**Appeal by Ministry of Justice
Land adjacent to HMP Garth and HMP
Wymott, Leyland Appeal Ref:
APP/D2320/W/22/3295556**

Rebuttal of Proof of Evidence

on behalf of Chorley Council

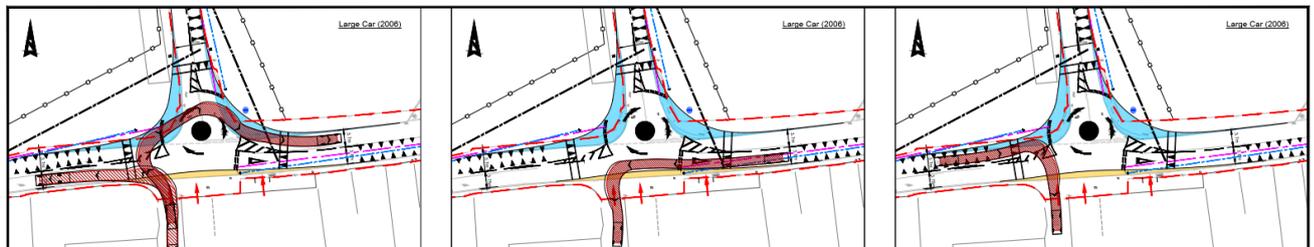
- 2.2.1 It is noted that the additional land enables an increase in the measured visibility compared to the previous design as effectively it is proposed to alter the fenceline and remove hedgerows.
- 2.2.2 However, given that the existing hedgerows along the A581 and Ulnes Walton Lane are not regularly maintained (as I highlighted in my Proof), regardless of whether the fence line is set back to achieve visibility on a plan, I question whether in reality visibility will be maintained. There is no detail on whether the land will be under the ownership of the Ministry of Justice, the Highway Authority or a third party, and therefore it is unclear who will be responsible for the maintenance.

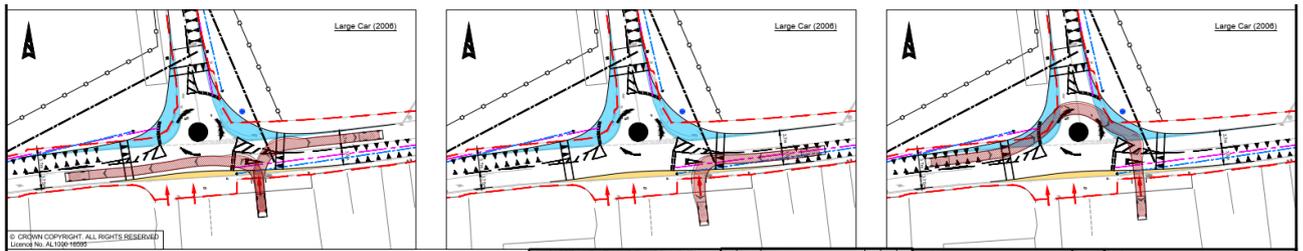
- 2.4.1 The proposed roundabout scheme does not address the issues I noted in my Proof regarding the presence of three private driveways on the southern side of the A581. The manoeuvres to and from these driveways are still unsafe and are a fundamental issue with delivering a mini-roundabout scheme at this junction. I refer to the swept path analysis in Appendix G DWG: GARTH_ATK_SPA_A581_DR_D_0016_P5 A (CD M10a – pdf page 18), a screenshot of which I have included below:

2.4.2 As shown in the left-hand image, a right-turning car would need to position itself at 90 degrees to the flow of the traffic to enter the roundabout before the giveway entry to the roundabout. A vehicle waiting in this position is both unsafe and will have an impact on the capacity of the junction as it will block the flow of vehicles exiting the roundabout to travel west on the A581. The alternative is for a vehicle to cut through the roundabout itself, which is also unsafe.

2.4.3 Similarly, the right-hand image shows a right-turn being made into the driveway before the roundabout across the hatched markings, which could cause confusion given the close proximity to the give-way, with drivers on Ulnes Walton Lane or the A581 east potentially expecting to give-way to a driver using the roundabout rather than accessing their driveway. These interactions within the junction could lead to accidents.

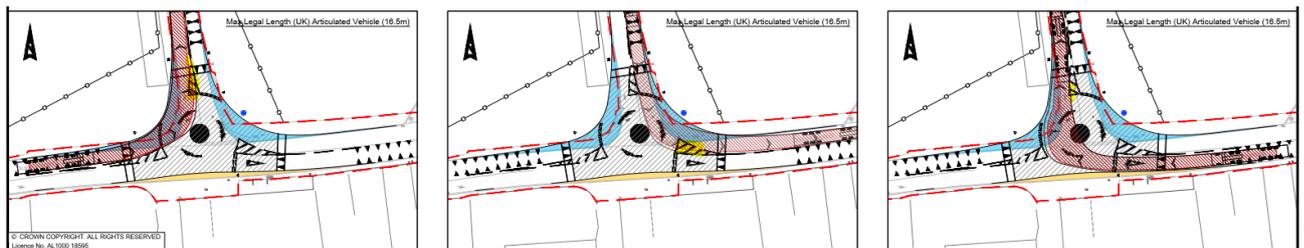
2.4.4 This also applies to the other drive-way to the far right:

2.4.5 The left-hand image shows a right-turning vehicle cutting across the entry and exit of the junction to turn right. This manoeuvre is unlikely to be expected by other vehicles using the roundabout and could lead to accidents.

2.4.9 The lack of kerb definition could lead to overrunning of private driveway/footway was noted in the original RSA undertaken by Hydrock (CD M3a – Appendix C – pdf page 18 – problem 2.4). Notably, we do not have an updated RSA undertaken by Hydrock but given there has been no change to the kerb on the southern side of the roundabout in the alternative scheme, we can assume this issue remains.

2.4.10 The RSA recommended “an appropriate kerb upstand is provided, and other measures introduced to ensure the kerb is conspicuous to road users entering the roundabout.”
